Re: BusConnects Belfield/Blackrock to City Centre Core Bus Corridor Scheme
Co. Dublin

Re. Planning Application by the National Transport Authority for the construction of the Belfield / Blackrock to City Centre Core Bus Corridor Scheme.

The Submission from Dun Laoghaire Rathdown County Council regarding the Belfield / Blackrock to City Centre Core Bus Corridor Scheme is set out hereunder.

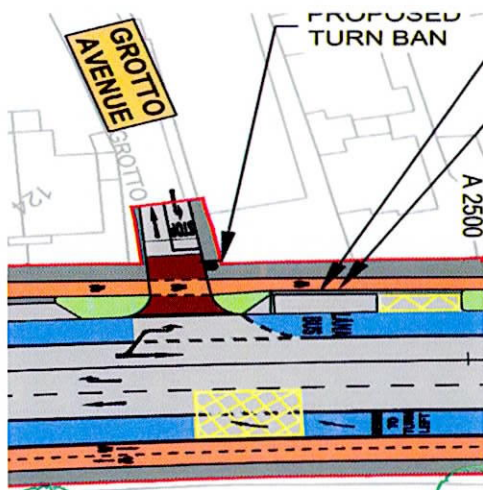
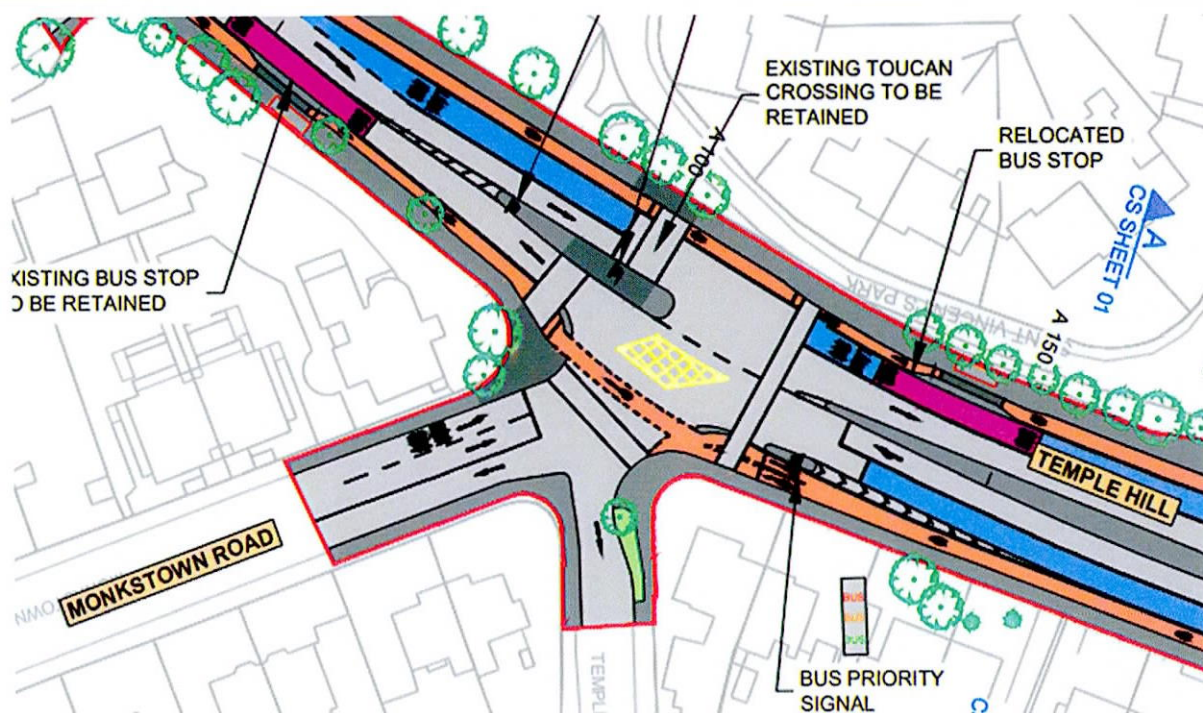
In the interest of pedestrian and cyclist safety, DLRCC has a requirement, where feasible, for the provision of continuous pedestrian and cycle facilities across side roads, similar in design to that proposed under the CBC scheme at Grotto Avenue (example 1 below). At other side road locations across the CBC scheme however, the cycle lane is at grade with the general traffic lane and not accommodated on the raised table (example 2 below).

DLRCC requests that the Board include a condition requiring prior engagement and agreement with DLRCC regarding the final design of the pedestrian and cycle facilities at junctions with side roads in order to ensure an approach which is consistent with the requirements of the Council.

Removal of Staggered Toucan Crossing at Temple Hill – Monkstown Rd Junction

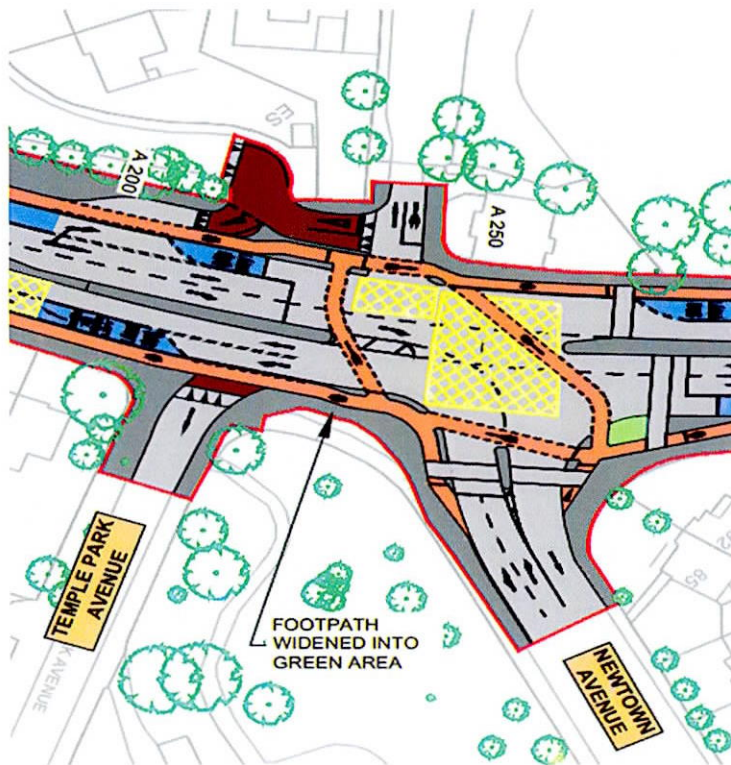
This junction includes a straight through pedestrian crossing on the Blackrock side. When this crossing runs, the only other movements that can run are the left turn out of Monkstown Rd and the priority right turn for buses coming off Temple Hill (from the Stradbroke Rd side). DLRCC considers it may be preferable to have an all red phase at this junction, which would allow the removal of the staggered toucan crossing and result in improved pedestrian facilities.

The Board is requested to consider this amendment and to also consider if a fully protected junction solution for cyclists might be more appropriate at this location and more consistent with the designs proposed at other junctions. The Board is requested to include a condition as appropriate requiring prior engagement and agreement with DLRCC regarding any changes to the final design and layout of this junction.

Approved Junction at Temple Hill, Temple Rd and Newtown Ave (ABP31232521)

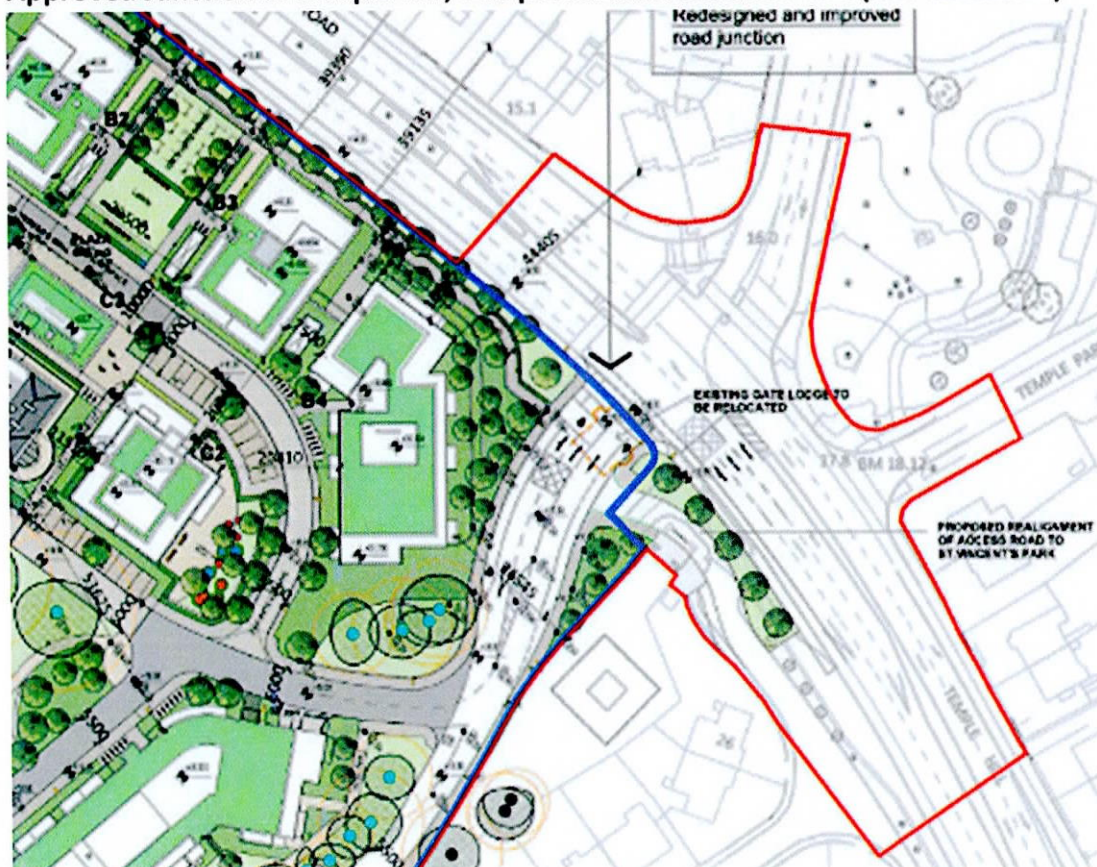
The proposed junction design at this location (shown below) results in a poorer layout for cyclists than pertains with the existing layout. Currently, cyclists coming from Newtown Ave, can move through the junction and join the city bound cycle lane directly. DLRCC has concerns that the proposed layout results in a poorer solution and reduced priority for cyclists.

Objective R18, as stated in Section 4.2.3 of the Blackrock Local Area Plan 2015 – 2025, indicates that it is an objective of the Council to facilitate the future upgrade of this junction at Temple Hill/Newtown Ave/St Vincent's Park in tandem with the redevelopment of the St Teresa's and Dunardagh's landholdings, in accordance with objective DS15 (St Teresa's and Dunardagh Site Framework Strategy). In this regard it is highlighted that under ABP31232521, permission has been granted as part of a Strategic Housing Development on nearby lands at St Teresa's, for the relocation of St. Teresa's Lodge and the redesign of this junction as per the layout shown below. This approved layout may accommodate an improved solution for cyclists at this junction.

DLRCC requests the Board to include a condition requiring prior engagement and agreement with DLRCC regarding the final design and layout of this junction in order to ensure it is consistent with the requirements of the Council and emerging development in the area.

Existing Junction Layout at Mount Merrion Ave. and Rock Road

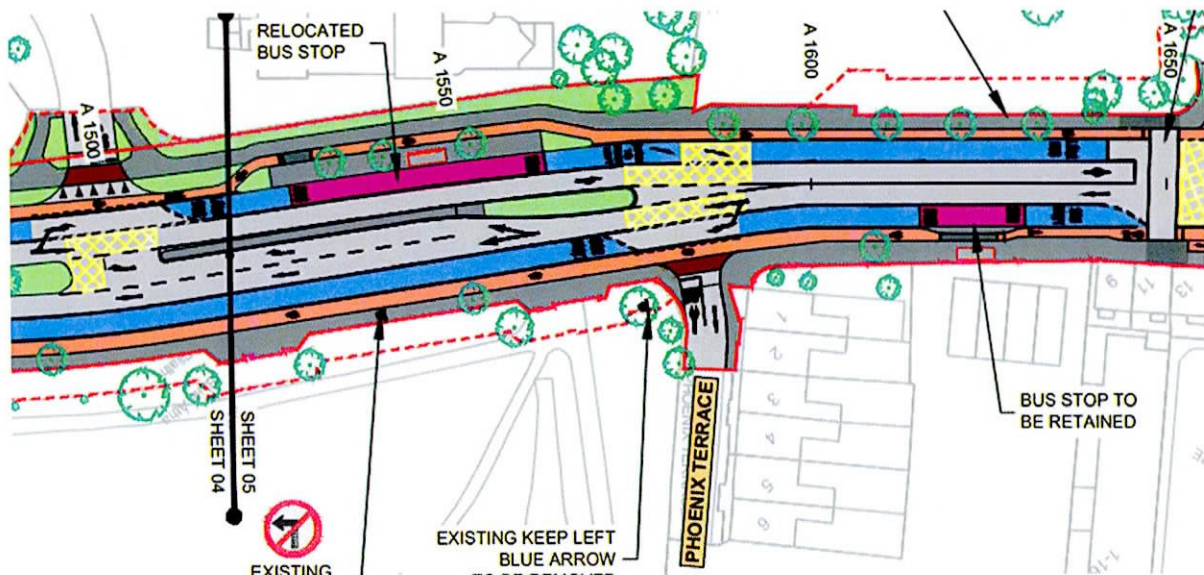
DLRCC has concerns that the proposed cycle lane on Mount Merrion Avenue leading to Rock Road is quite narrow for such a busy route. In addition, there are concerns that the proposed junction design, which omits the existing left turn cycle slip lanes leading from Mount Merrion Ave. to Rock Rd and from Rock Road to Mount Merrion Ave, will result in a reduced level of service for cyclists. DLRCC requests the left turn cycle facilities (as currently exist) be incorporated into the proposed junction design to improve convenience for cyclists and avoid unnecessarily bringing cyclists through the signalised junction. DLRCC considers that ample space is available to safely accommodate these amendments and give extra priority for cyclists.

DLRCC requests the Board to include a condition requiring the amendment of this junction design to include a wider cycle lane on Mount Merrion Ave leading to the junction and to incorporate the left turn cycle facilities (as currently exist). The final layout and design of this junction to be submitted for the prior agreement of DLRCC.

Entrance to Castledawson and Opposite Blackrock Park

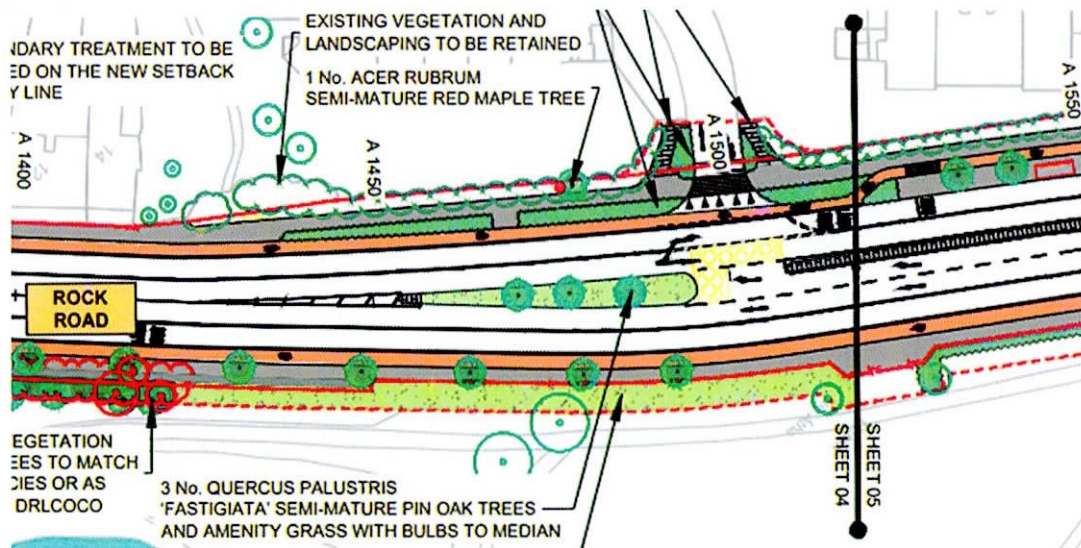
The large green areas shown below opposite Blackrock Park and adjacent to the entrance to the Castledawson estate, have the potential to incorporate trees. DLRCC considers trees essential along this stretch of carriageway, which is wide and in an exposed coastal location.

Trees, however, may not be possible within the narrow footpath section adjacent to Blackrock Park and shown above. DLRCC questions the need for the kick in the footpath making it narrower at this location.

Green Areas Adjacent to Entrance to Willow Terrace

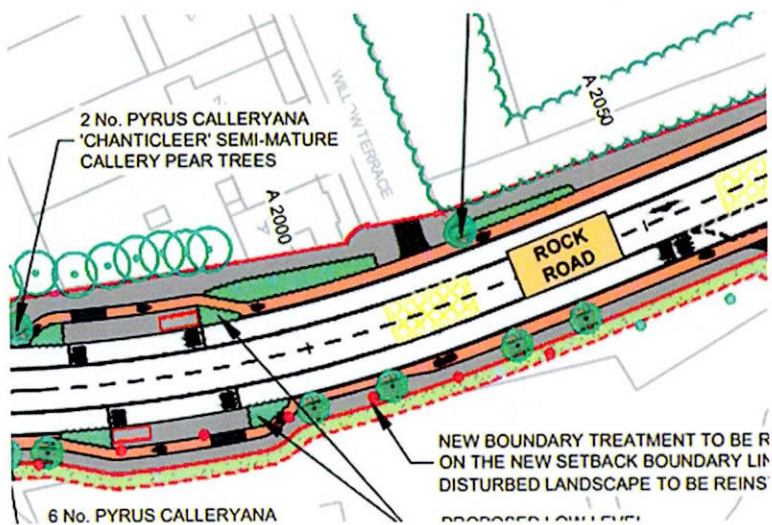
The green areas shown below adjacent to the entrance to Willow Terrace and adjacent to Blackrock Park, have the potential to incorporate trees. DLRCC considers trees essential at these locations, where the carriageway is wide and in an exposed coastal area.

Landscaped Median on Temple Road

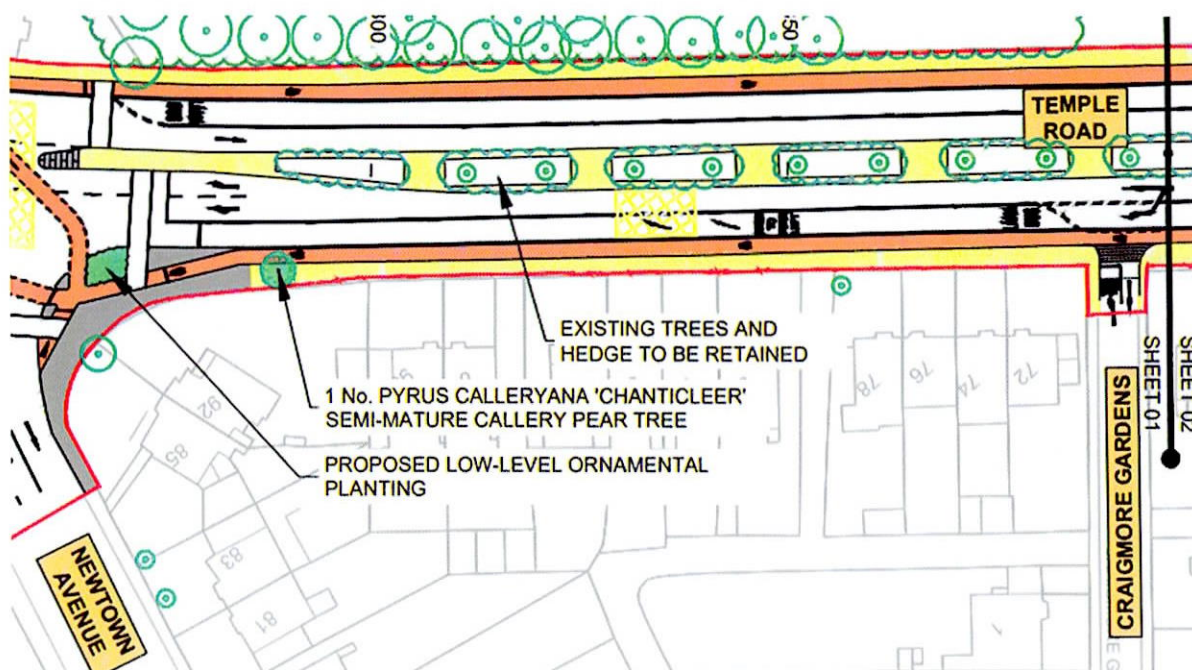
In the interest of achieving a coordinated and coherent landscape response across the proposed corridor, DLRCC requests that the landscaped median on Temple Rd, shown below, be included in the landscape design for the scheme with the existing Buxus groundcover to be replaced with a herbaceous mix with all soft landscaping to be amalgamated into one large bed and extended out to the kerb lines.
